Berths 226 to 236 [Everport]
Container Terminal Improvements Project

Final Environmental Impact Statement/
Environmental Impact Report
And
Draft General Conformity Determination

September 2017

Figure 5-1: Percent of Minority Population (by Census Tract)

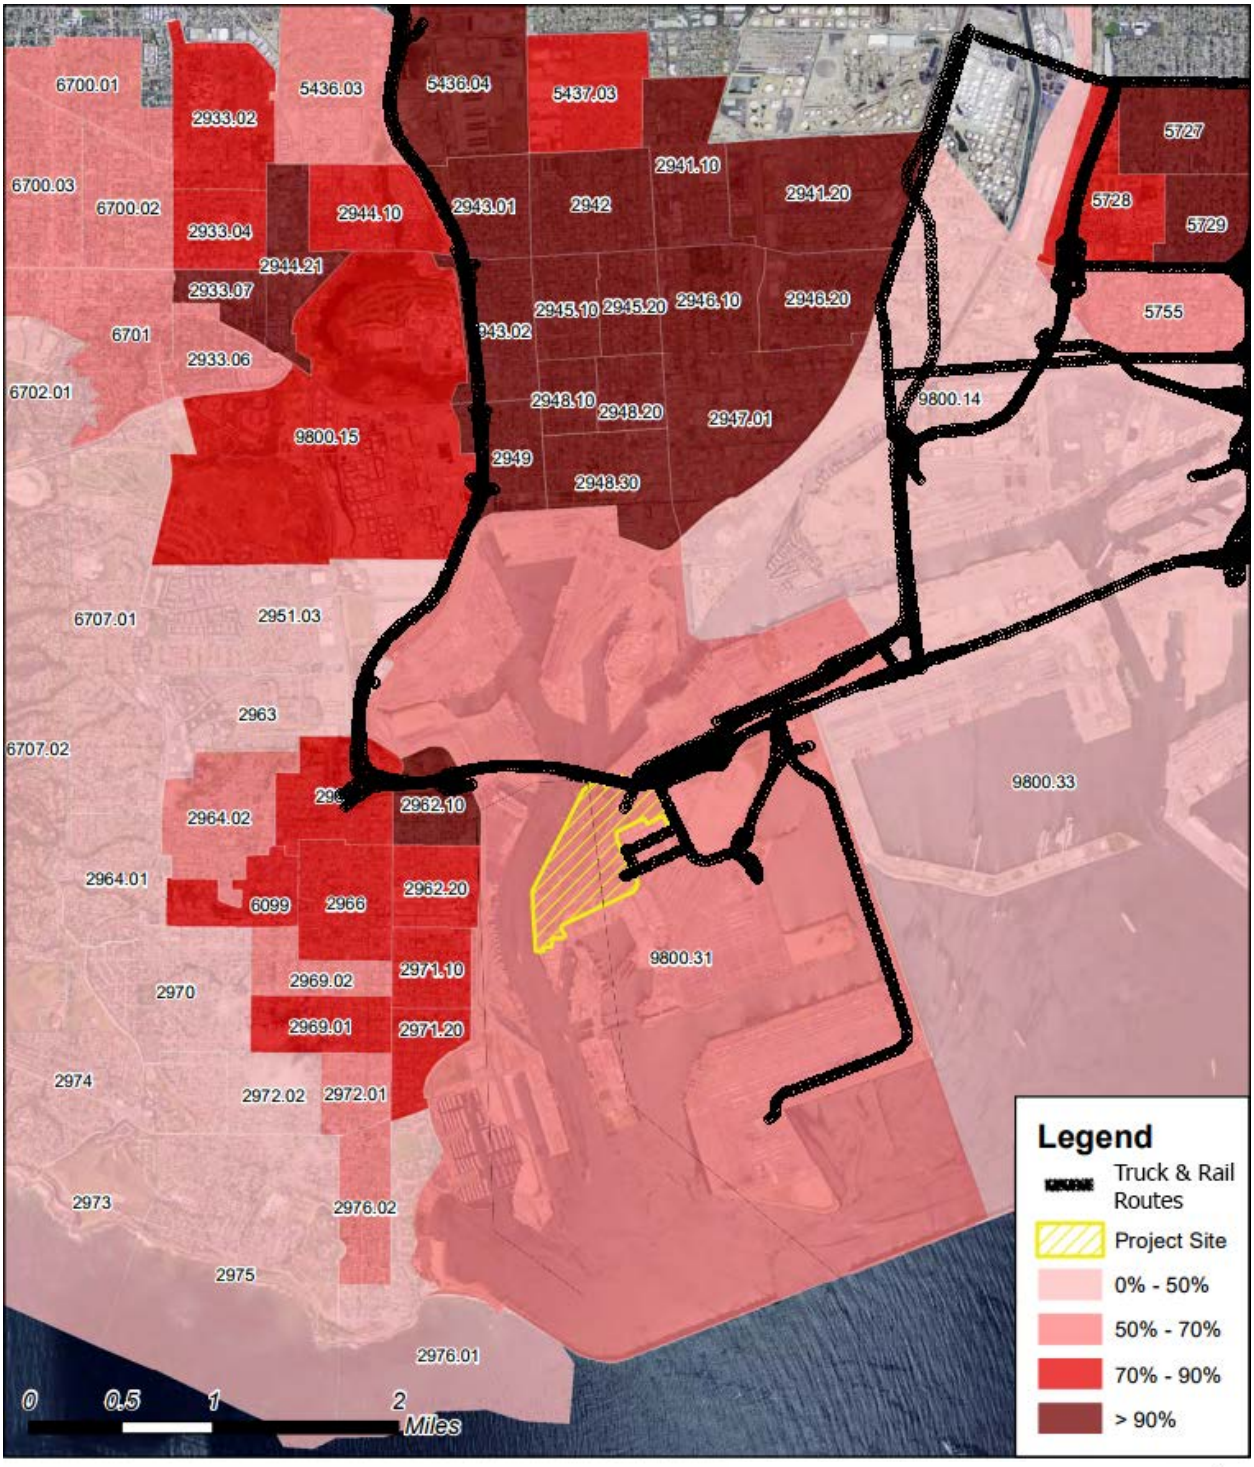
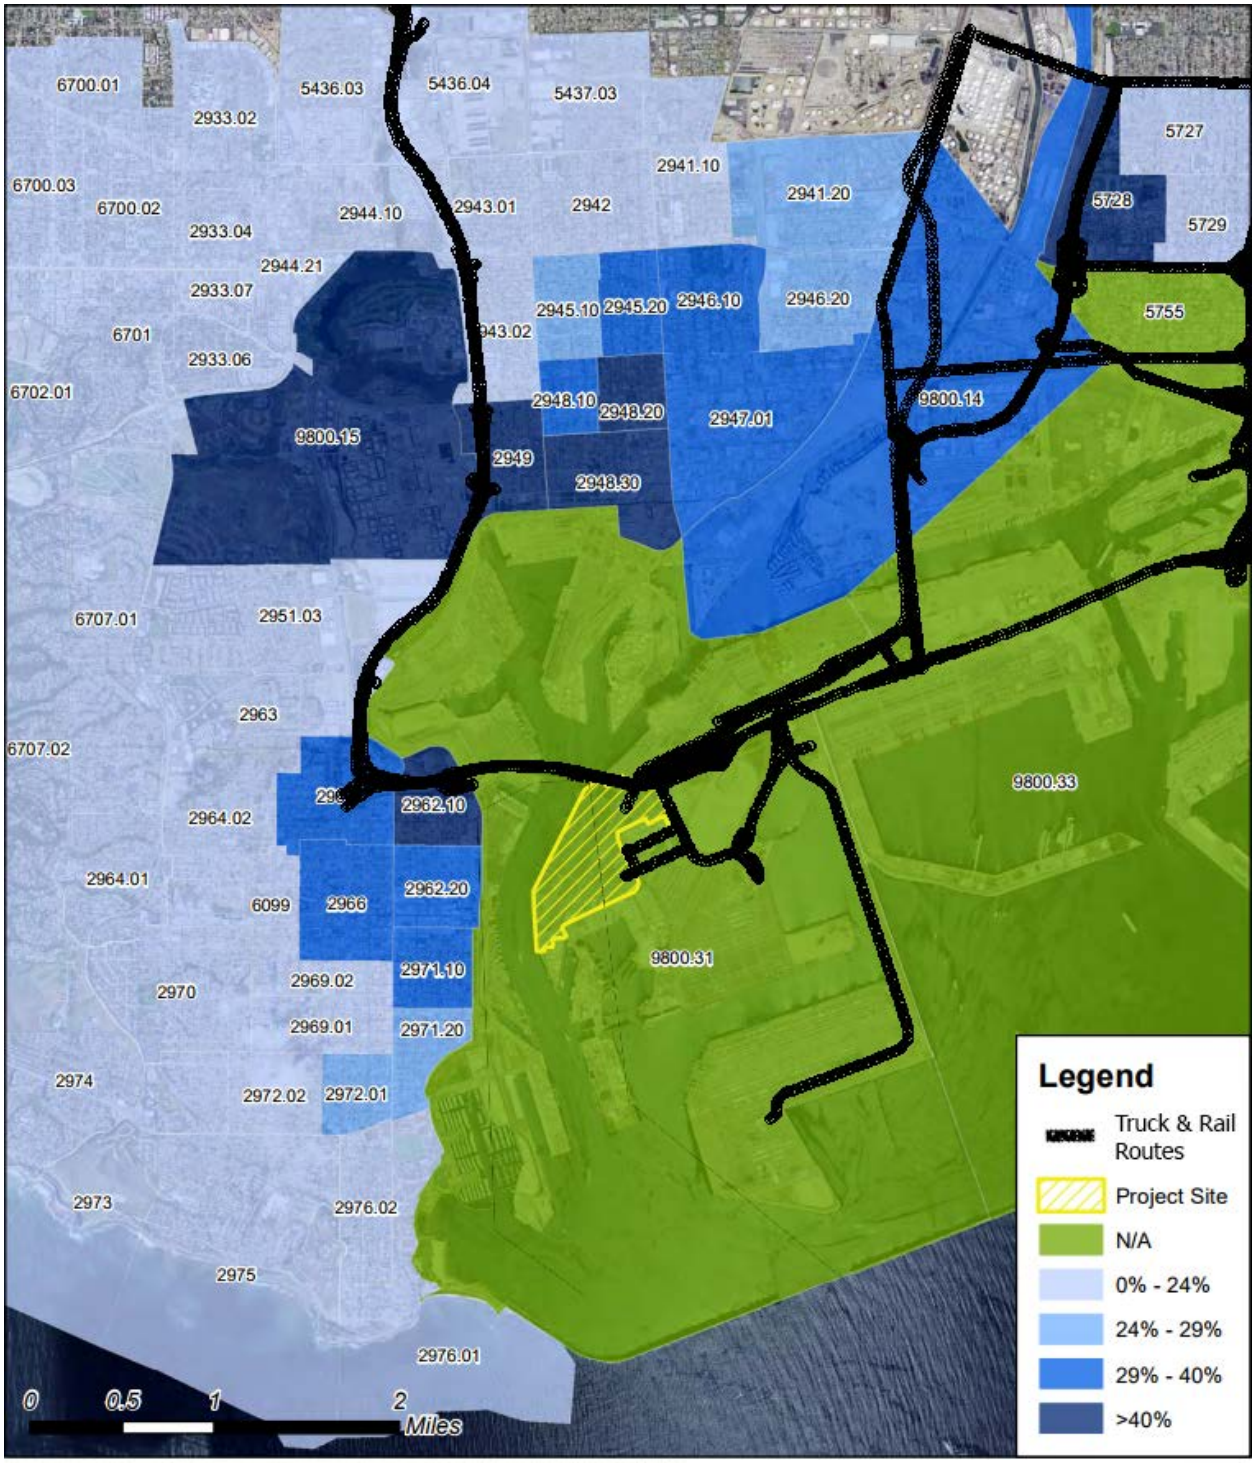
According to Chapter 2, the Proposed Action would result in 7,028 average daily truck trips during peak months in 2038—an increase of 2,213 average daily truck trips compared to the NEPA baseline (p. 2-4). Figure 3-1 of Appendix B2, which illustrates offsite vehicle source locations, suggests that truck routes associated with the project would traverse low-income and minority communities identified in Figures 5-1 and 5-2 of Chapter 5; however, this map does not indicate the number of trucks expected to use each route. Disclosure of such information is important to inform decision-making regarding project design and mitigation needs, and to enable affected communities to understand how the project would impact their neighborhoods and health.

The comment is noted. Communities develop over time around major highways. Truck travel associated with Port activities uses the major highways wherever they are situated. Truck routes used during construction are discussed in Section 3.6.4.3 (page 3.6-53) of the Draft EIS/EIR. For the commenter's convenience, the following graphics overlay Figures 5-1 and 5-2 from the Draft EIS/EIR with potential,

assumed truck routes during project operation. While it is unknown the exact route any individual truck may take, as can be seen truck routes likely would be situated in a manner that minimizes impacts to communities, including minority and low-income housing, thus minimizing potential impacts associated with operational truck trips.
